SUBJECT: Application for amend to License DPR-31 & DPR-41 revising
 Tech Specs to reflect results of ECCS analysis on power
 distribution limits for steam generator tube plugging level
 of 25%.Supplements 800213 amend request.

Re: Turkey Point Units 3 and 4
Docket Nos. 50-250 and 50-251
Proposed Amendment to Facility
Operating Licenses DPR-31 and DPR-41

Figure 3.2-3b

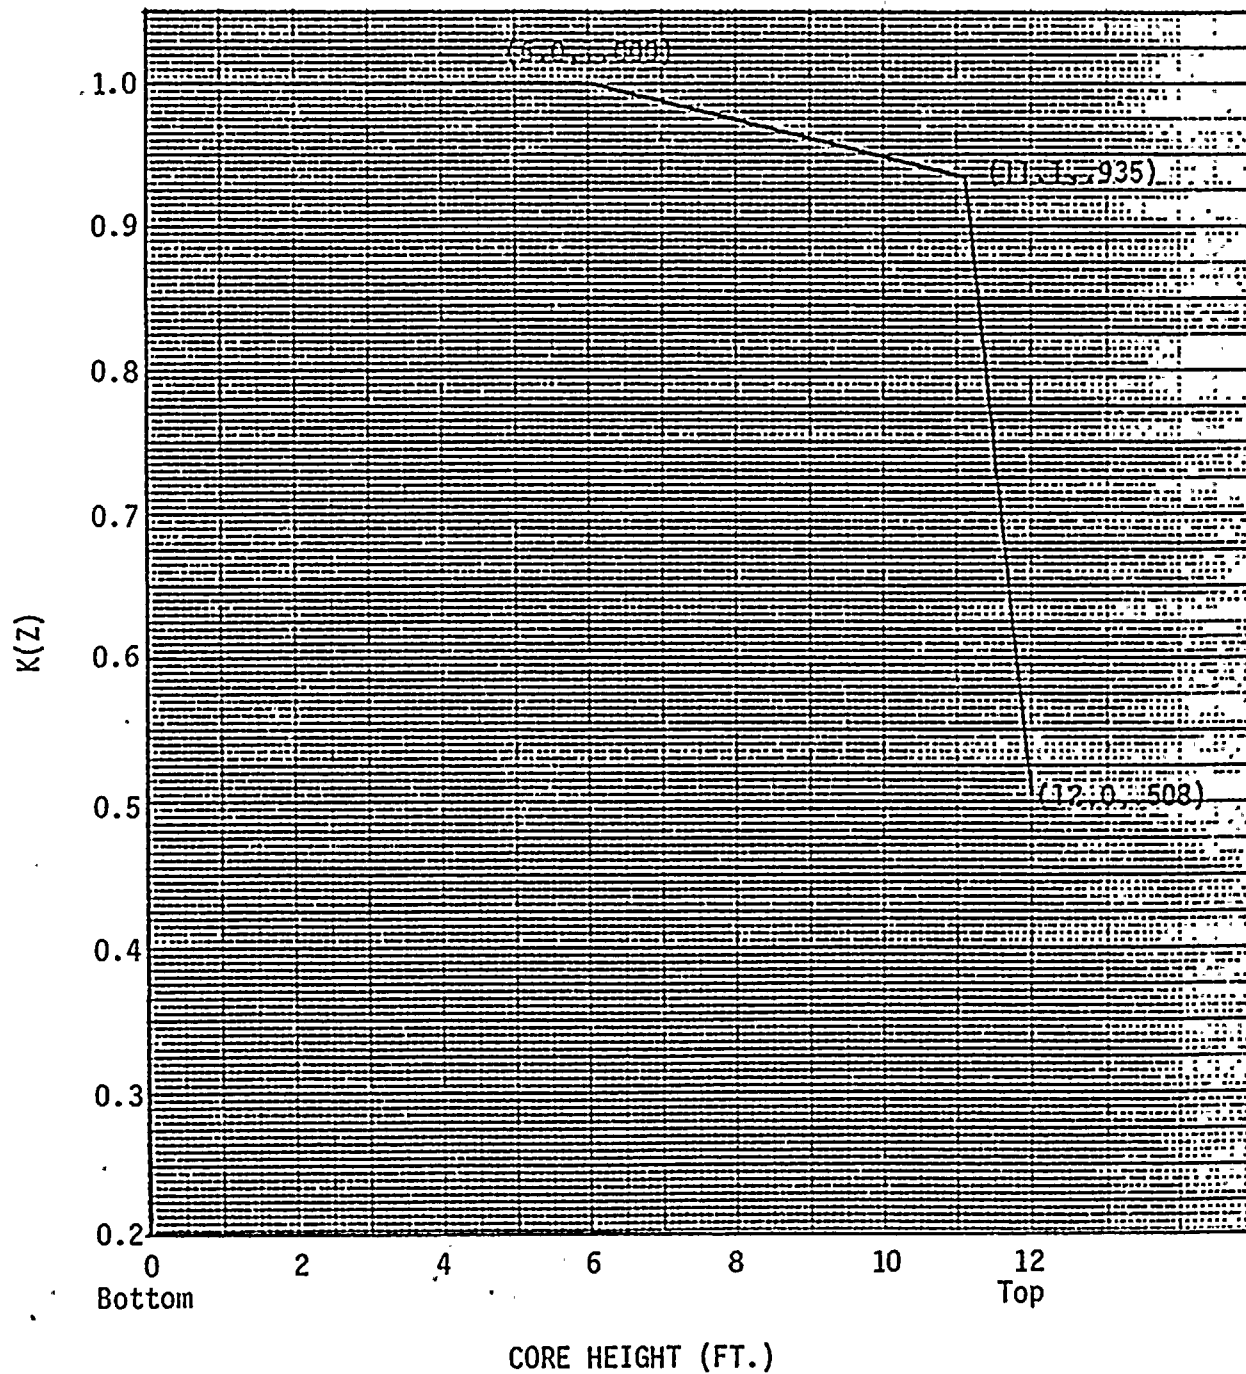
Figure 3.2-3b

The normalized hot channel factor operating envelope for a steam generator tube plugging level of 25% is revised to reflect the results of a recent ECCS analysis.
